METROPOLITAN GOVERNMENT OF NASHVILLE AND DAVIDSON COUNTY

STAFF RECOMMENDATION 1810 Ashwood Avenue April 16, 2014

Application: Partial demolition; New construction—addition
District: Belmont-Hillsboro Neighborhood Conservation Zoning Overlay
Council District: 18
Map and Parcel Number: 10416007800
Applicant: Kaitlyn Smous, Allard Ward Architects
Project Lead: Melissa Baldock, melissa.baldock@nashville.gov

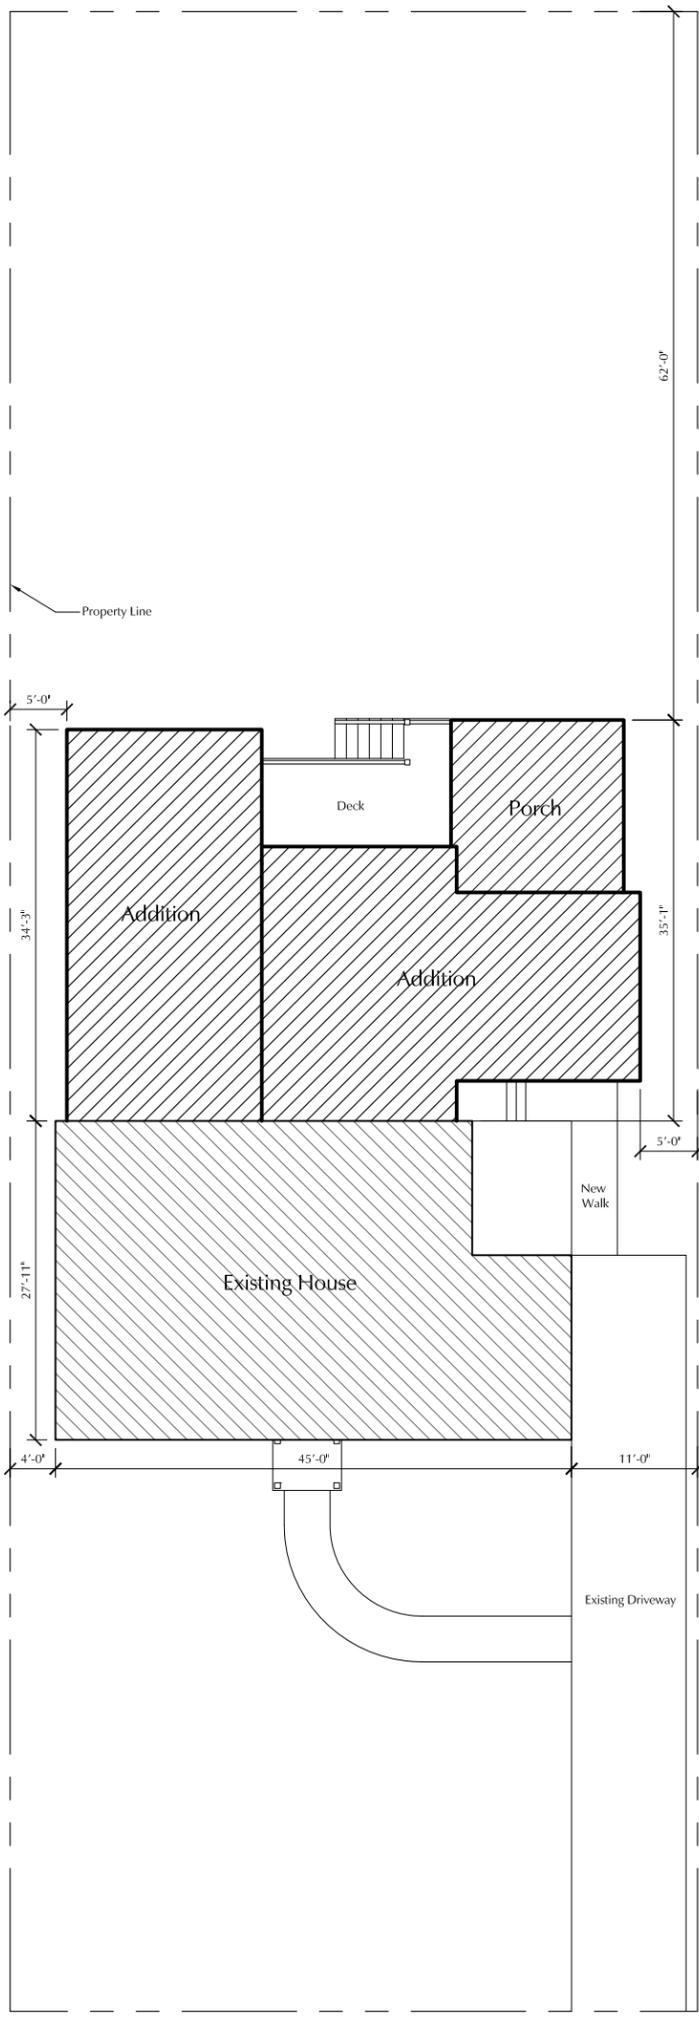
Proportion and Rhythm of Openings: One change to the existing window openings was indicated on the plans. On the east façade, behind the enclosed porch, a new window opening will be added that matches the existing window opening (Figure 7). Staff finds that the addition of a window opening in this location is appropriate because it is located at the rear of the historic house, behind the enclosed porch, and it will at most be minimally visible. The new window openings on the side porch enclosure are compatible with the fenestration pattern of enclosed porches. The windows on the proposed addition are all generally twice as tall as they are wide, thereby meeting the historic proportions of openings. There are no large expanses of wall space without a window or door opening. Staff finds the project's proportion and rhythm of openings to meet Sections II.B.1.g. and II.B.2. of the design guidelines.

Figure 7 shows the proposed location of a new window opening.

1 First Floor Demo Plan
 Scale: 1/8"=1'-0"

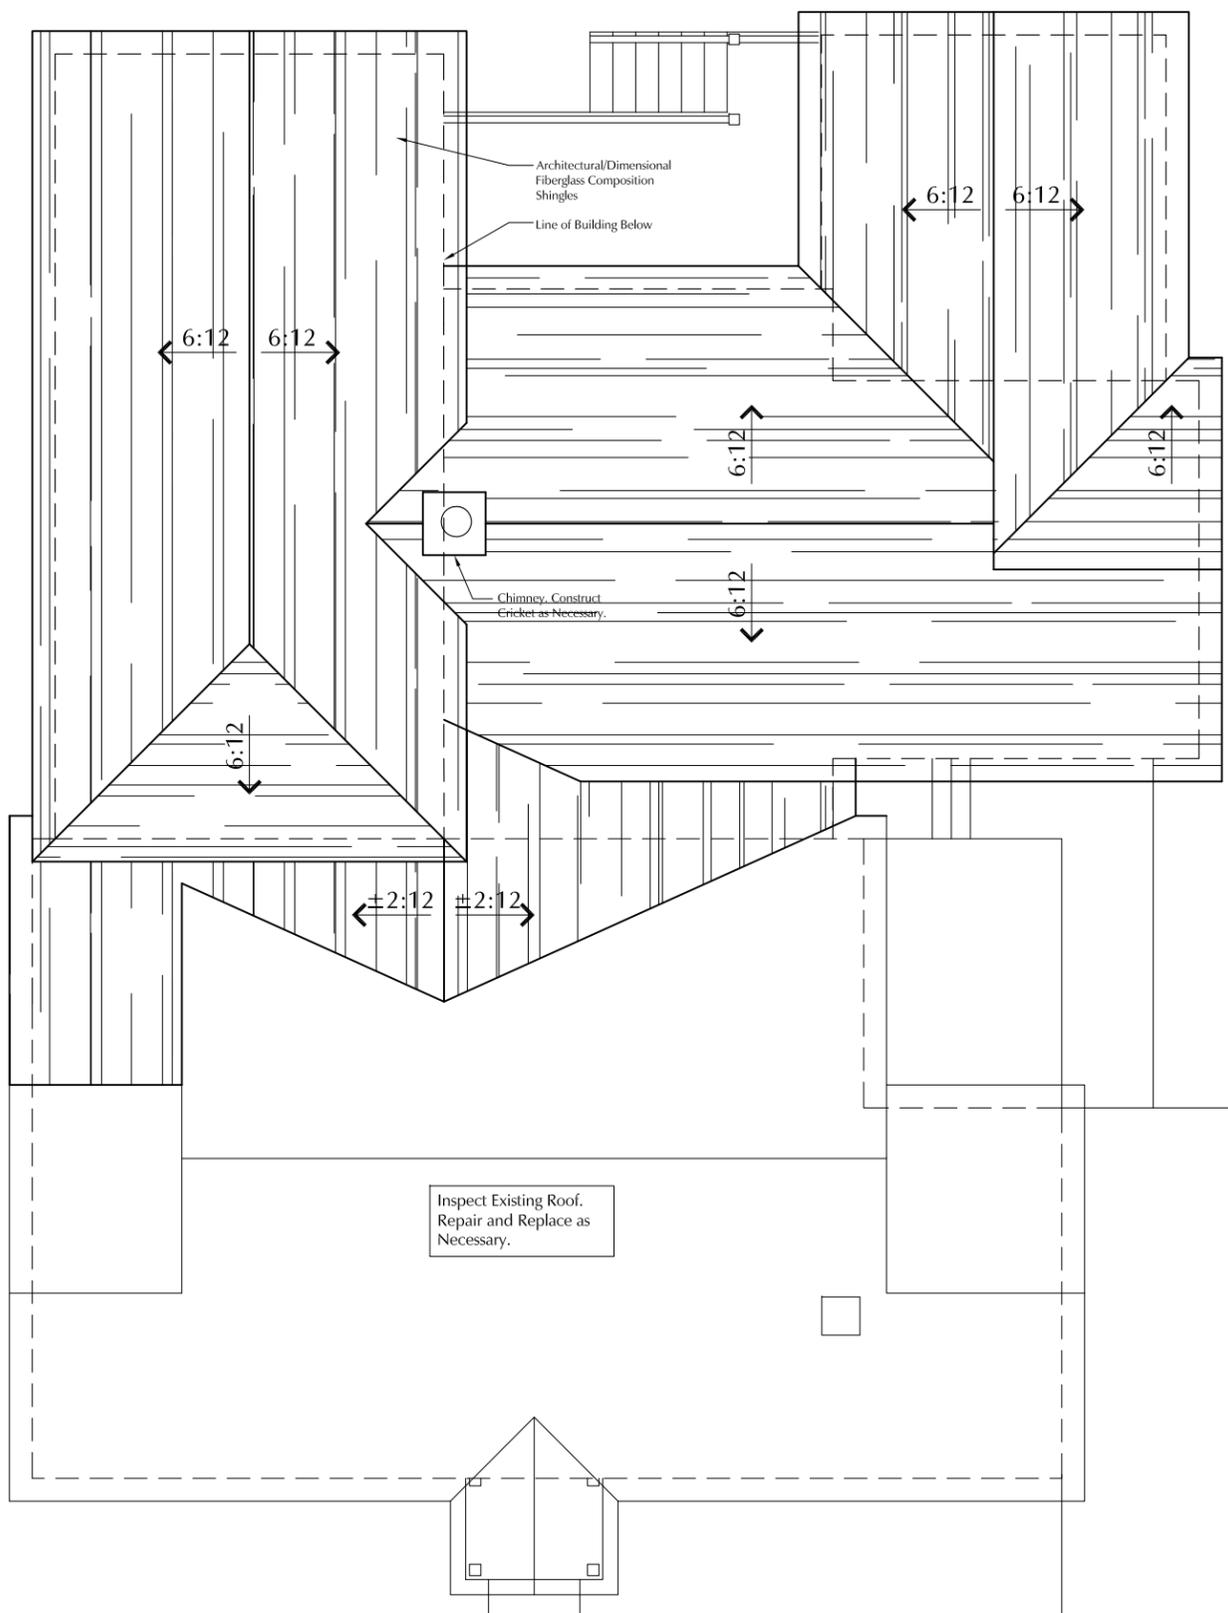
Partial Demolition: The applicant proposes to demolish a non-historic and non-contributing addition and to alter a previously enclosed side porch. The rear addition is located on the west side of the property (Figures 2 & 3). On the side façade, one can see evidence that this part of the house was likely built separate from the original structure (Figure 4). This addition is not visible from the public street, and its demolition will not adversely affect the historic character of the house or the historic Belmont-Hillsboro neighborhood. Moreover, the addition is in poor structural condition. Staff finds that the demolition of the addition meets the design guidelines.

The eastern part of the house was originally an open side porch that was later enclosed (Figures 5 & 6). The applicant is proposing to remove the existing enclosure and to construct a new enclosure that is more in keeping with aesthetics of typical enclosed porches. Staff finds that the removal of the existing enclosure for the side porch will not adversely affect the historic character of the house or the historic neighborhood. Staff finds the removal of the enclosure to meet the design guidelines.

A seven foot, two inch (7'2") deep portion of the existing addition that is to be demolished on the west side will be reconstructed in the exact same location, matching the eave height of the existing house. The remainder of the addition steps in one foot (1') on the west side, and one foot, four inches (1'4") on the east side. On the west side, the addition extends back approximately thirty-four feet, three inches (34'3") and is inset for the entire expanse. On the east side, after a depth of three feet, six inches (3'6"), the addition expands out approximately sixteen feet (16'), which is six feet (6') wider than the historic house. The addition will have a maximum depth of approximately thirty-five feet (35') and a maximum width of fifty feet (50').
